From: **Tom McCormick** tommccormick@mac.com 
Subject: 150-foot buffer and other buffers should be based on OHMW
Date: May 1, 2018 at 7:16 PM
To: Ryan Countryman ryan.countryman@snoco.org, Paul MacCreedy paul.maccreeady@snoco.org
Bcc: Tom McCormick tommccormick@mac.com

I-348 McCormick, Tom -- May 1, 2018
PFN: 11 101457 LU

A-051

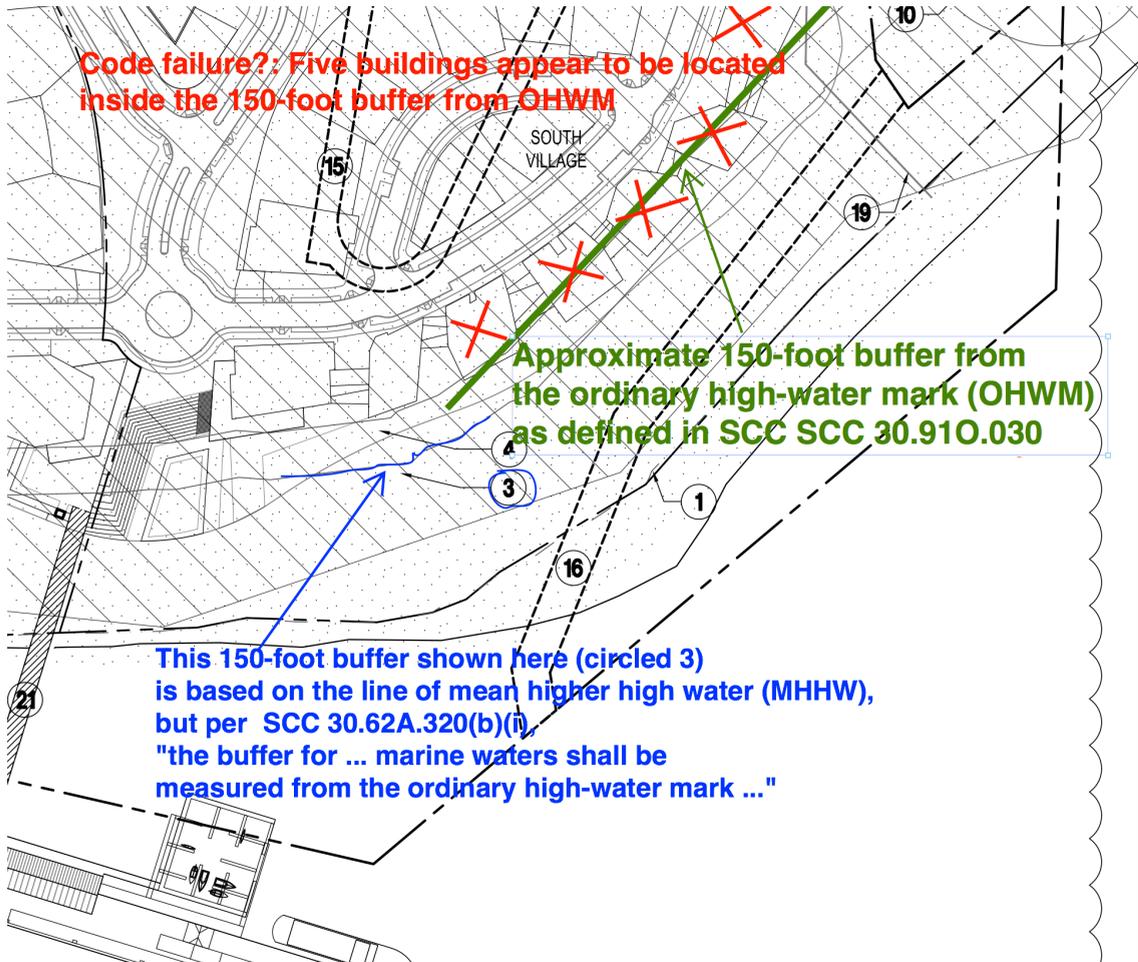
Since the DEA biologist found and recorded the OHWM, shouldn't the OHWM be used to measure the 150-foot marine buffer line? The OHWM is not used. Instead, the submitted drawings show the 150-foot marine buffer line and the 200-foot shoreline management zone measured from the line of mean higher high water (MHHW). Aren't the submitted drawings defective?

I note that the OHWM appears to be roughly 50 feet farther inland than the line of MHHW in front of the five most southern buildings in the South Village. As a consequence, it appears that those five buildings are located within the 150-foot buffer. (See the two snippets attached.) In contrast, in the current (defective?) drawings which measure the 150-foot buffer from the line of MHHW, all five of those buildings are located *outside* the 150-foot buffer. Does the Code require that all buildings be located *outside* the 150-foot buffer? It seems like the developer went out of its way to locate all buildings in all villages *outside* of the 150-foot buffer.

If I am correct about measuring the 150-foot buffer and the 200-foot shoreline management zone from the OHWM instead of the line of MHHW, then the submitted UC drawings and the Short Plat drawings are defective and out of compliance. Are there any other issues to be concerned about? Can the developer build within the 150-foot buffer? I see that per SCC 30.62A.320(c)(i), no new effective impervious surfaces are allowed within the 150-foot buffer, but I also see that there are methods to reduce the buffer width. And how is the 200-foot shoreline management zone impacted, and the 300-foot submittal requirement rule in SCC 30.62A.130(1)(f) and (g) and the special buffer rule in SCC 30.62A.320(1)(c)(ii)?
